# WEBER COUNTY PLANNING DIVISION

# Staff Report for Administrative Approval

Application Request: Consideration and action on the application for final approval of Family Dreams Subdivision

**Applicant:** Jeff Burton File Number: UVF091925

## **Location Map 1**

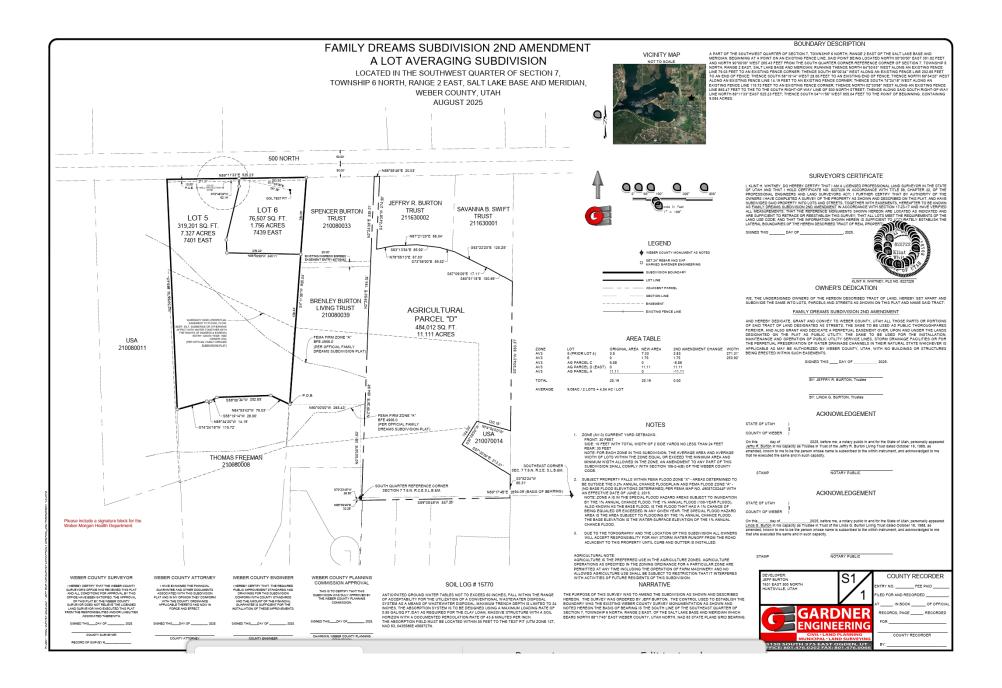
There is a portion of lot 3 that is located in the S-1 zone, as shown on the location map 1 below. Lot 5 meets the minimum lot area requirement of the S-1 zone of 5 acres.
